Attachment 1 2019 Development Charges Correspondence Received

James Sylvestre Developments Ltd. 1865 Manning Road Tecumseh, Ontario N8N 2L9 (519) 735-6606

RE: Development Charges Background Study doted June 13, 2019

Manning Road -St Gregory's Road to Riverside Drive E.

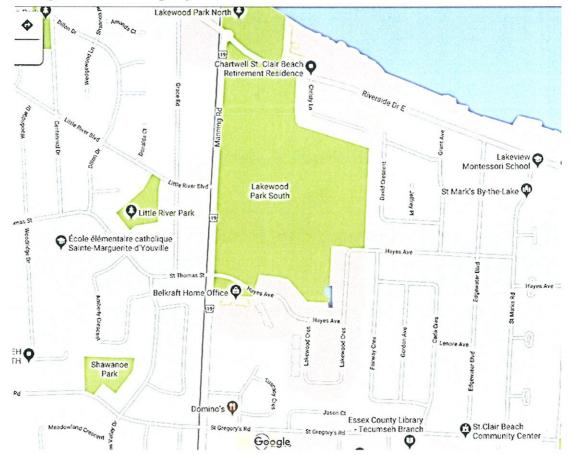
2. The Reduction for Benefit to Existing Development is explained at a high level on p 4-10 of the Development Charges Background Study document. On this basis, we had anticipated a greater Benefit to Existing Development for new facilities within existing/fully built-out areas of our Town. I've included a GoogleMaps image of the example provided during the public meeting for ease of reference. The surrounding area appears to be fully built-out.

- p5-12. Active Transportation/ Project No. 1 Manning-St Gregory's to Riverside (Bike Lanes) A Gross Capital Cost Estimate of \$331,300 has a **10%** deduction for Benefit to Existing Development.
- p5-11 *Roads, Sidewalks and Streetlighting* This same road segment appears again as Project No. 1 with a deduction of **84%** for Benefit to Existing Development.
- p5-3 *Indoor and Outdoor Recreation Services/* Project No. 5 Lakewood Park Master Plan Improvements A Gross Capital Cost Estimate of \$2,150,000 has **0**% deduction for Benefit to Existing Development.

We appreciate the offer to investigate this allocation in advance of the meeting scheduled to adopt the bylaw. We further request that if an alternate approach to identifying the reduction for benefit to existing development is subsequently recommended, that this be considered for application across the full list of projects contained within the tables of the report.
